**TECHNICAL SERVICES
ADVISORY MEMO 10-0428**

Subject: RD-8 CSR ELECTRICAL RELAY WIRING

RD8 Service Announcement for Refer

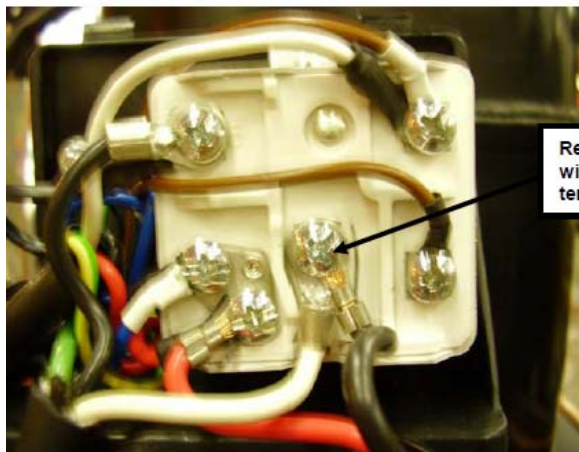
GE POTENTIAL RELAY 3ARR3BAV3 After review of the specifications and the circuits of the relay, it has been determined that the current wiring of the relay may be a potential cause of failures in the field.

GE statement on the circuit states that, "If there is a terminal in position # 6, it must be in the same polarity as terminals #1 and # 4 to prevent possible flashover," The wiring originally on #6 is a different polarity. It is the same as terminal #5.

To prevent the possible flashover between terminals #4 and #6, which can result in a shorted relay, capacitors or compressor, the two wires at terminal #6 must be removed from the relay, cut the ring terminals off the wires, strip back the insulation ½ inch," and connect the two wires together with a wire nut.

Relay Termination
This represents the terminal connections

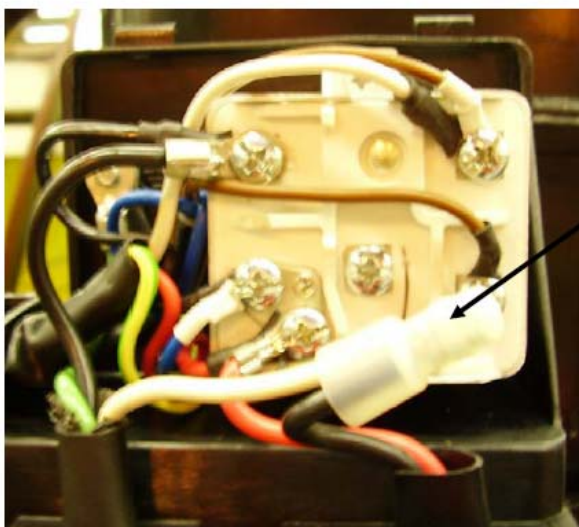
- Step #1** Locate the CSR Electrical box, and remove the cover.
- Step #2** Remove the two wires attached to terminal #6 of the Relay.

Remove both wires from terminal 6

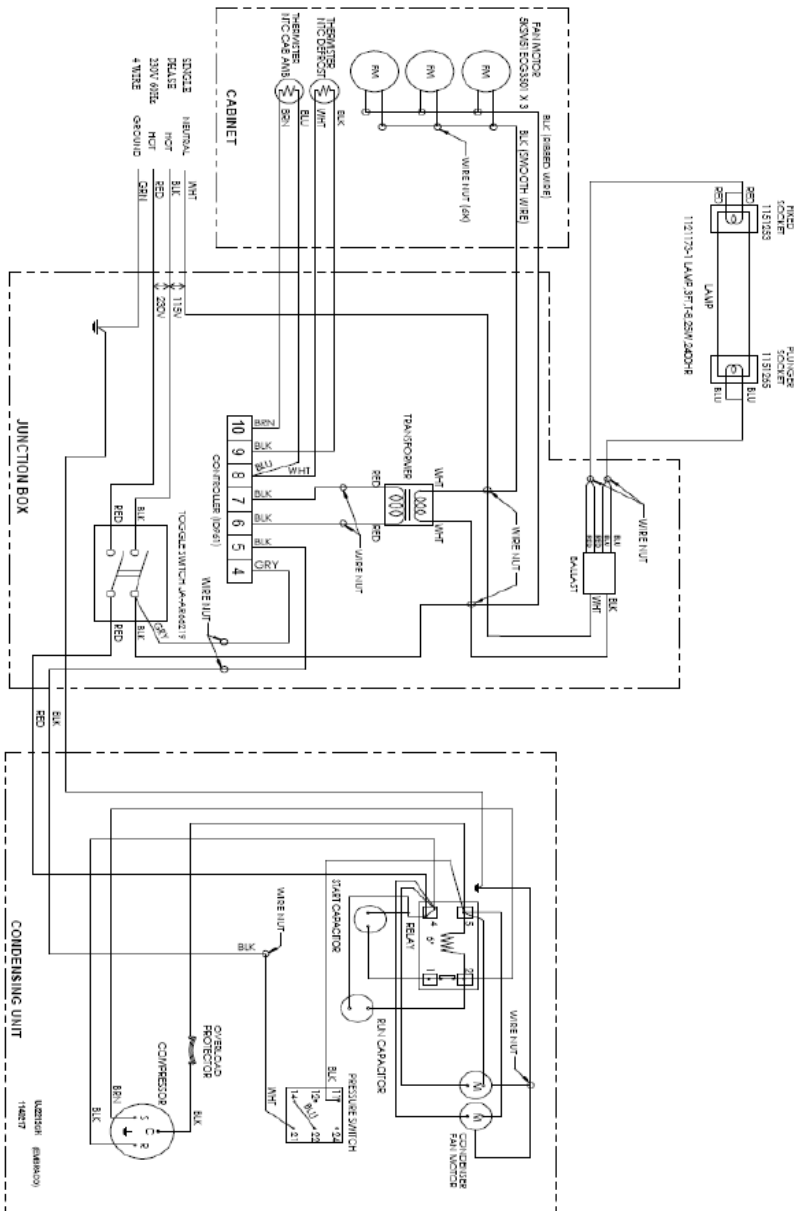
- Step #3** Cut off the closed loop terminals on both wires and strip the insulation back ½ ". Use a wire nut to connect the wires. Replace the cover.

Connect wires using a wire
